Docket Item #13
BAR CASE #2005-0202

BAR Meeting
October 19, 2005

ISSUE: Conceptual Review of 18 multifamily units

LOCATION: 1300, 1306, 1312 & 1320 Duke Street

Figure 1 - Site plan

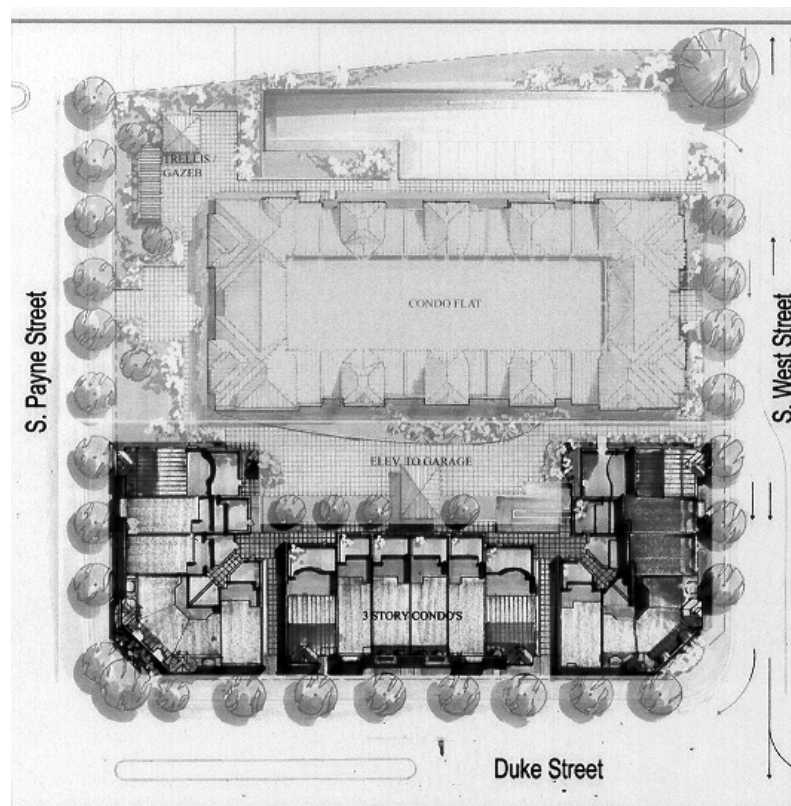
F-1 FDCs are obstructed by planters or parking spaces. All FDCs shall be clearly visible and directly accessible from either West Street or Payne Street. Landscaping shall be kept clear of FDC locations.

Figure 4 - Payne Street elevation

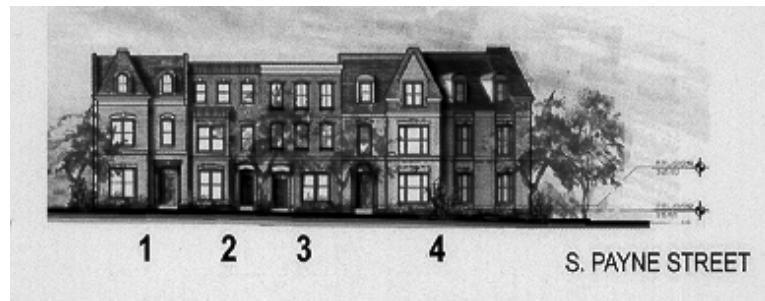
Staff believes the siting, massing, height, general fenestration, roof forms, and spacing between

the buildings is appropriate and conforms to the *Design Guidelines* for new multi-family residential construction (New Residential Construction - Pages 5-6). Staff believes the street front elevations of the three buildings are extremely well-thought out. The six facade types are used through the three buildings in a way that provides both variety and harmony. As commonly seen in historic rows, each of the three clusters contains repeated facades (in reverse pairs or as bookends). The Victorian detailing reflects the Italianate and Queen Anne style houses of the historic district without directly copying. For the most part, design elements are appropriate to the style of the facade. The architectural detailing is generally commensurate with the quality and quantity of detailing found on historic structures in the district. The side elevations are also acceptable. They relate well to the adjacent front facade and are appropriately treated as simpler, secondary elevations. Staff's initial impression of the rear elevations was that they are too different from the front elevations. They reflect current design trends rather than mid- to late-19th century architectural practice. On further consideration, Staff believes the rear facades are acceptable because they are related to the fronts by their use of common materials, but most importantly, because they will not be viewed with the front facades.

In general, Staff believes the proposed materials are appropriate. The Board's subsequent review of the final design will provide an opportunity to review the materials in more detail. However, Staff does feel it would be useful to raise some concerns at this time. In order to ensure that this important and highly visible project is of the highest quality, Staff makes the following recommendations:

1. The windows on the front and side elevations should be wood true divided light windows;
2. The railings should be painted galvanized steel rather than aluminum; and,
3. The pre-cast elements should be cast stone.
